**Re: Review of Solid Earth manuscript se-2021-109**

Dear Dr. Healy and the Solid Earth editorial board:

Xiaodong Ma (on behalf of all co-authors)

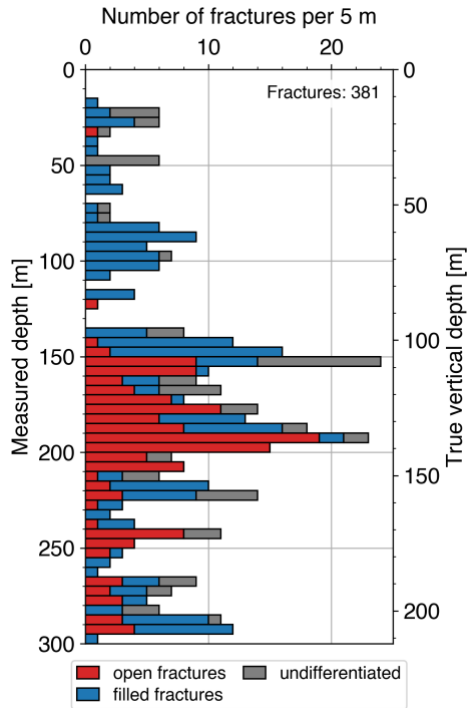
- Figure 4: Are all fractures treated similarly? It would be interesting to see the open vs. closed fracture count and perhaps plot major fault zones which were intercepted.

The following/attached fracture histogram shows three different fracture categories: open fractures, filled fractures (corresponds to closed fractures, these are generally infilled by biotite and/or quartz), and undifferentiated fractures. The last category represents fractures which cannot be identified with certainty whether they are open or filled. The major fault zones are represented by an increase of the open fracture count, and numerous with varying extent are intersected by the boreholes. The consistent picking of the fault zones, their classification, and correlation between boreholes is still ongoing and involves data sets that image the fault zones away from the borehole wall, e.g. GPR measurements. We will report the results in one of our upcoming publications.

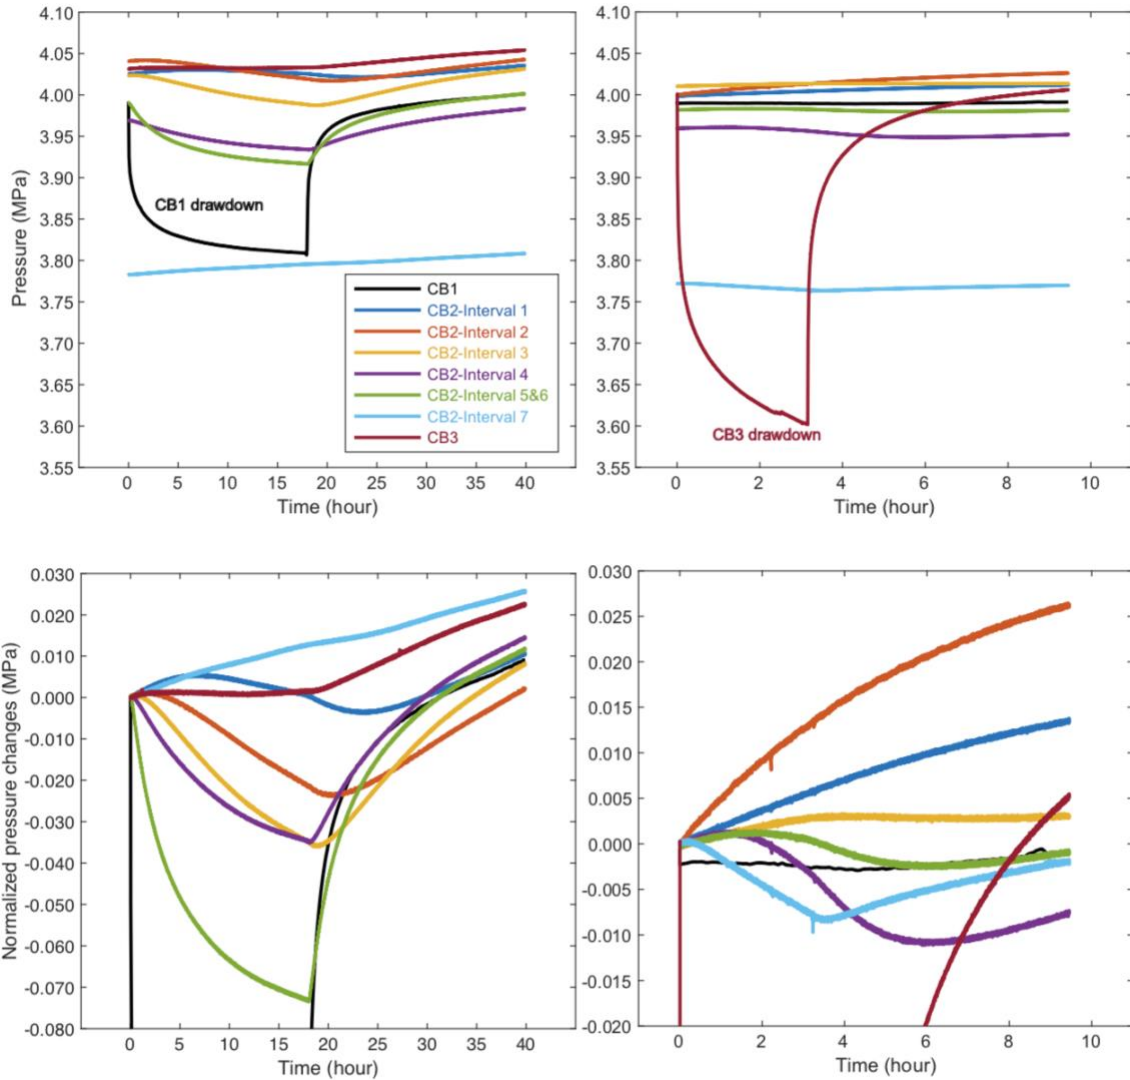
- Figure 10: Please normalise this figure so that simply drawdown is shown. (Assuming either a water density or simply showing the change in pressure. CB2 interval 1 looks odd, and usually one isn't concerned with the absolute pressure in these types of tests.

Please see the figure attached below. The relative pressure changes are provided in a normalized fashion. This figure is included in the revised manuscript.
